APPLICATION NO: 20/2019/0318/ AC

PROPOSAL: Details of hard and soft landscaping scheme submitted in accordance with Condition 5 of planning permission Code No. 20/2016/1137

LOCATION: Land West of Wrexham Road Llanfair Dyffryn Clwyd Ruthin

PROPOSED FENCE DETAIL TO REAR OF BARNFOLD

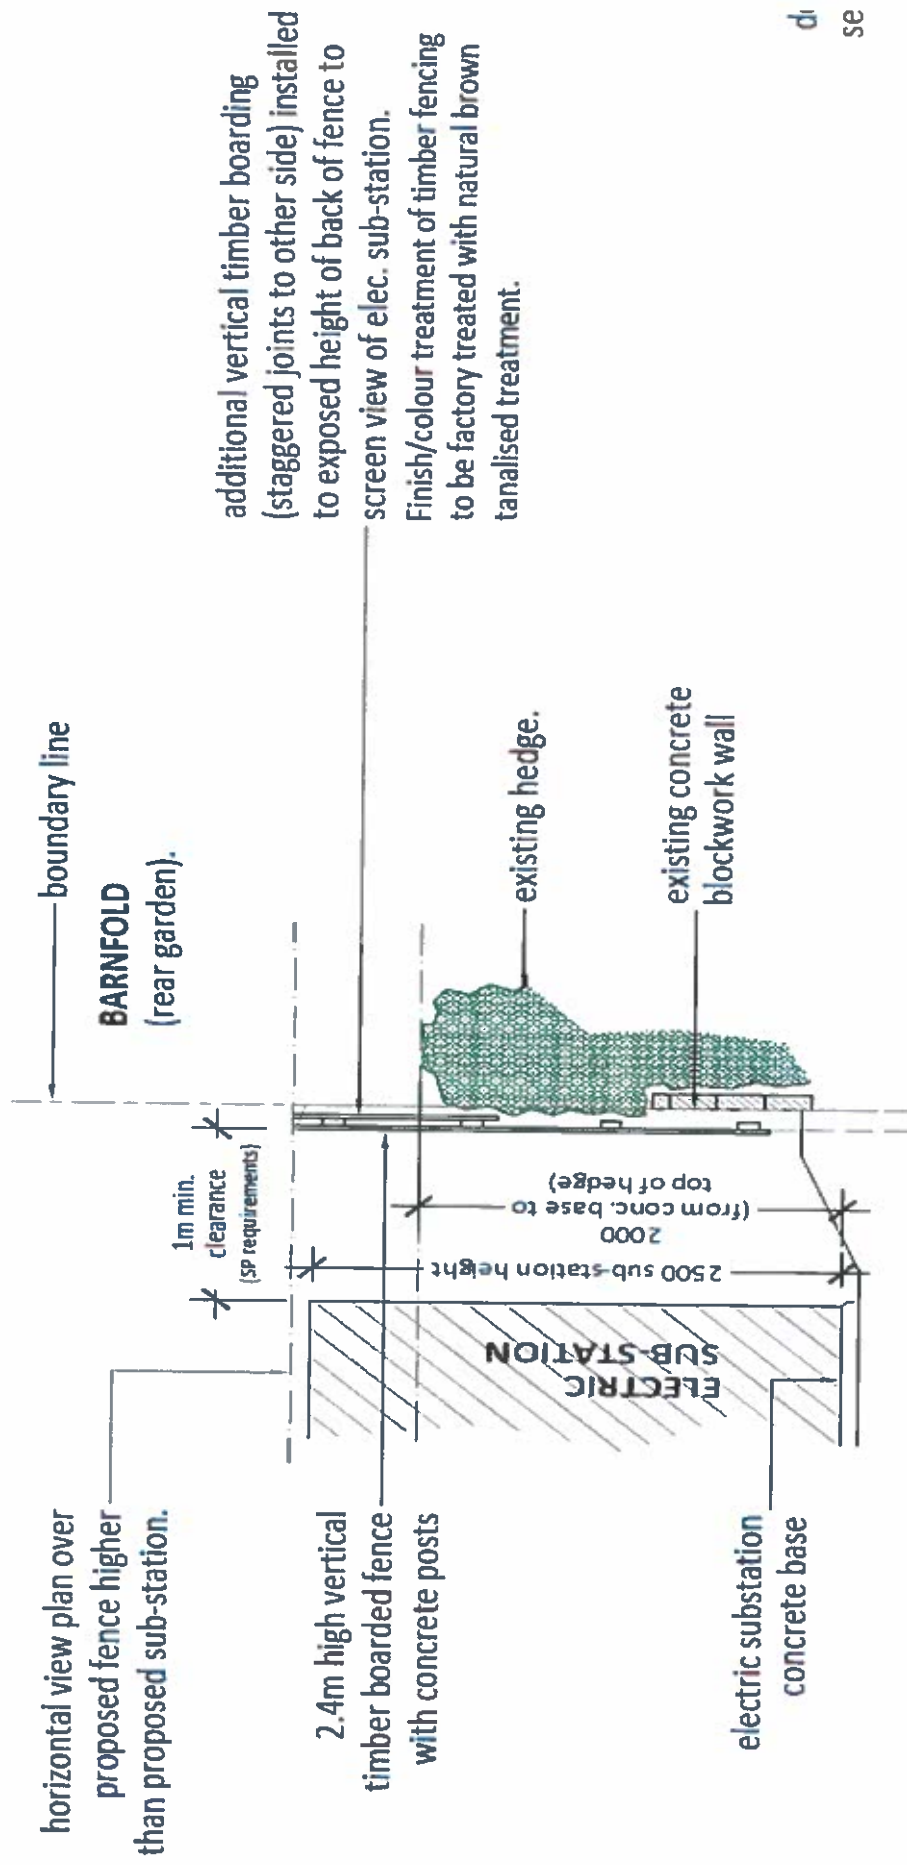
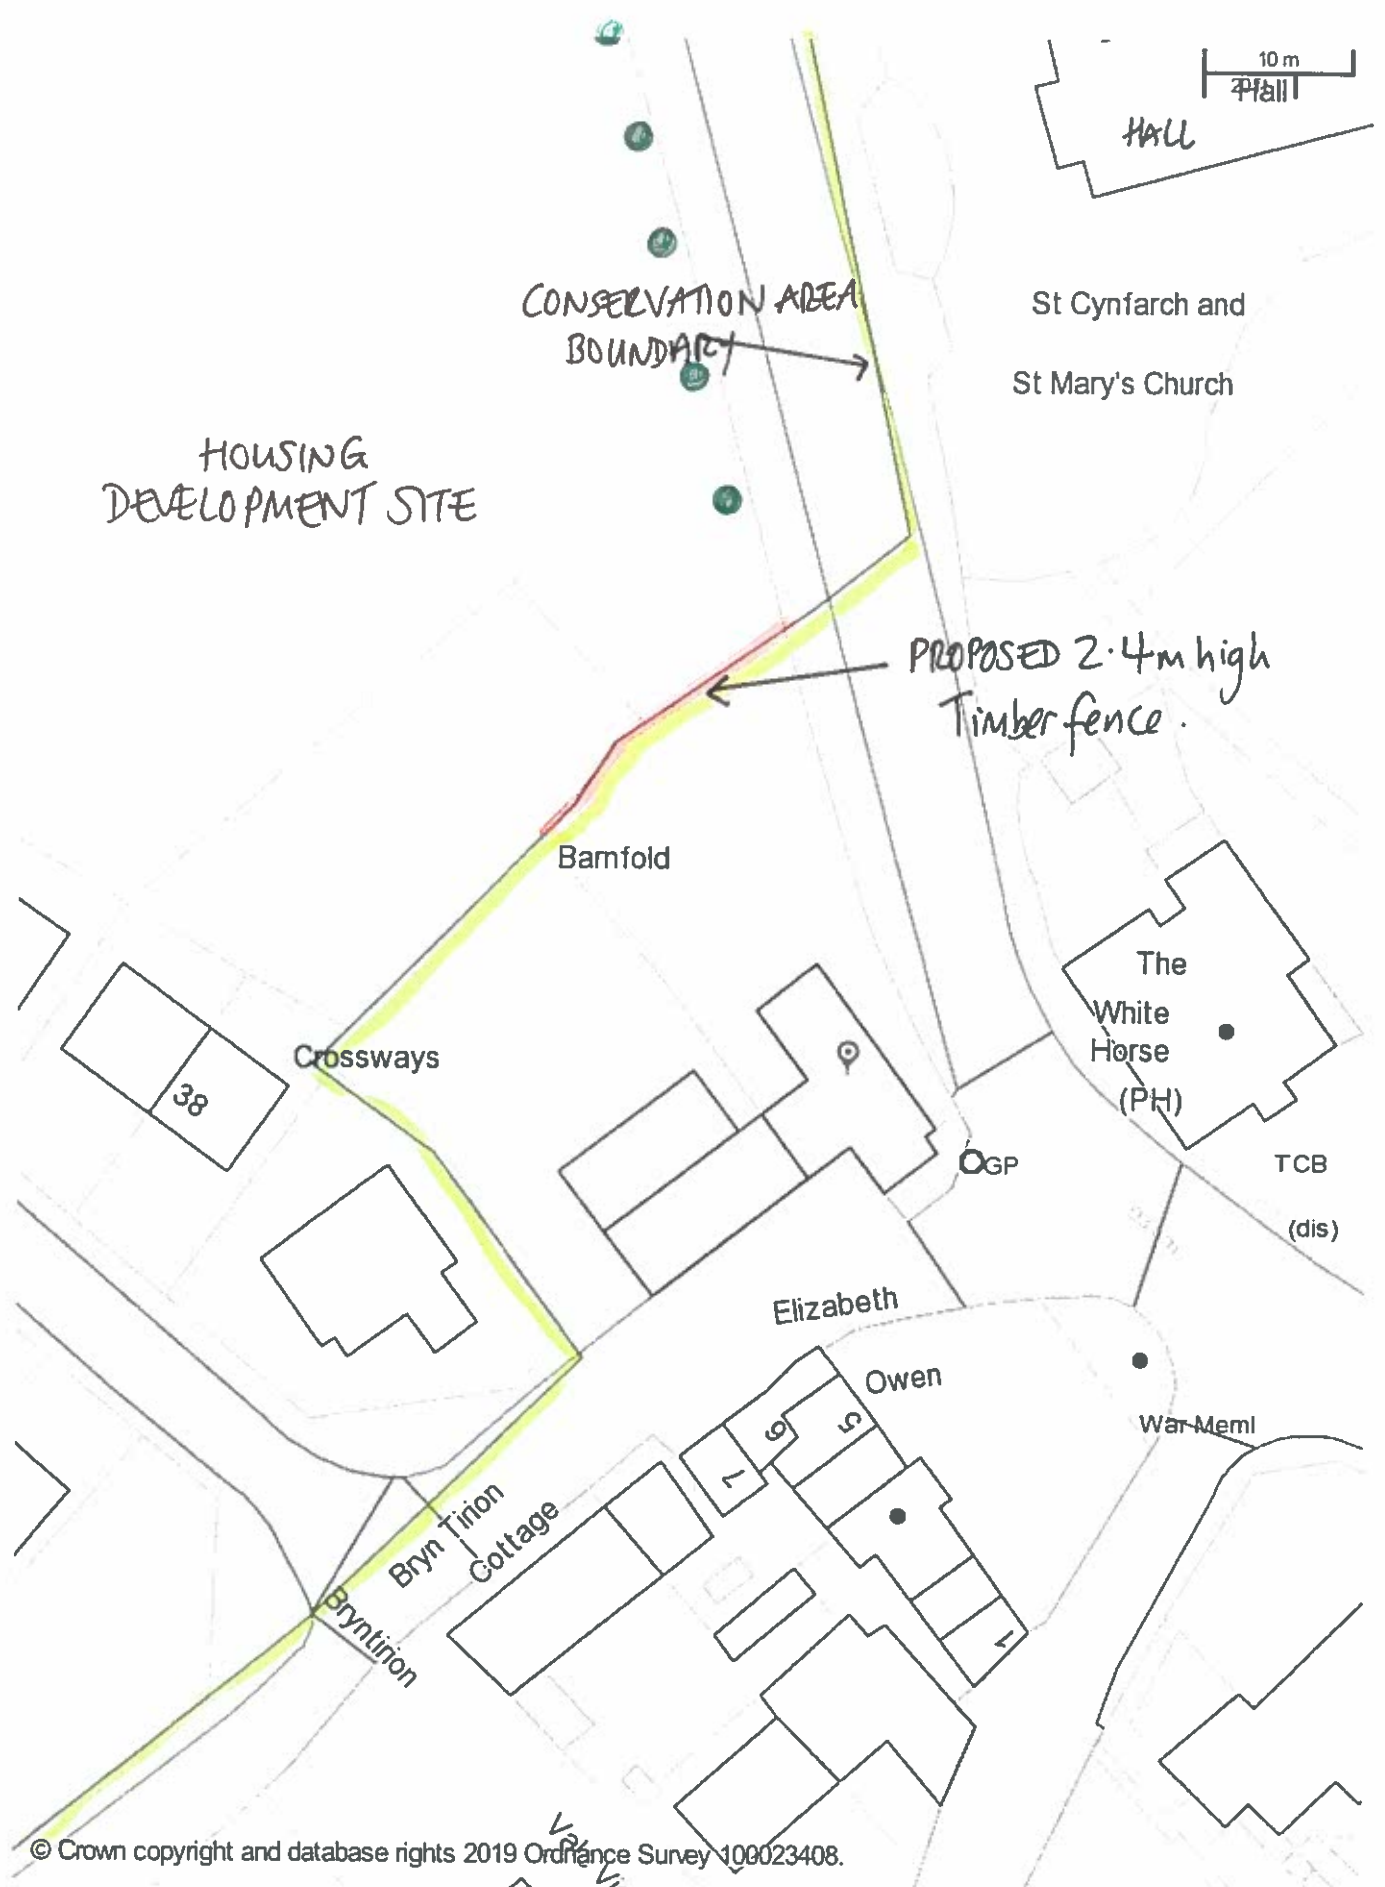
A timber fence along the boundary of Barnfold, located within the Conservation Area is not appropriate, it does not preserve or enhance the character and appearance of the area; the wall should be constructed of stone.

As noted previously, the height of the fence proposed to be erected within the application site, running parallel to the existing blockwork wall at the rear of Barnfield has been raised from 1.8m as originally proposed, to 2.4m in response to the concerns raised regarding the visual impact of the substation in close proximity to the boundary with that property. The plan at the front of the report illustrates the details.

Officers acknowledge the concerns voiced over the appropriateness of use of a timber fence along the boundary Barnfold. However, in respecting these concerns, in Officers' opinion it is important that due consideration is given to the fact that the boundary in question has been defined for some time by a blockwork (not stone) wall, and is in a location largely obscured from public view by existing mature hedgerow and trees, hence whatever boundary treatment is adopted in this position, it will be barely visible on approach to the village of Llanfair from the north or from any public viewpoints inside or outside the Conservation Area. Consequently, it is not considered reasonable to insist on construction of a 2.4m high stone wall in this location.

Officers therefore consider that the proposed timber boundary fence in this location, would not be unacceptable or adversely impact on the visual amenity of the area, or on the character and appearance of the Conservation Area. The natural brown finish proposed would complement the natural landscaping within the vicinity of the boundary.
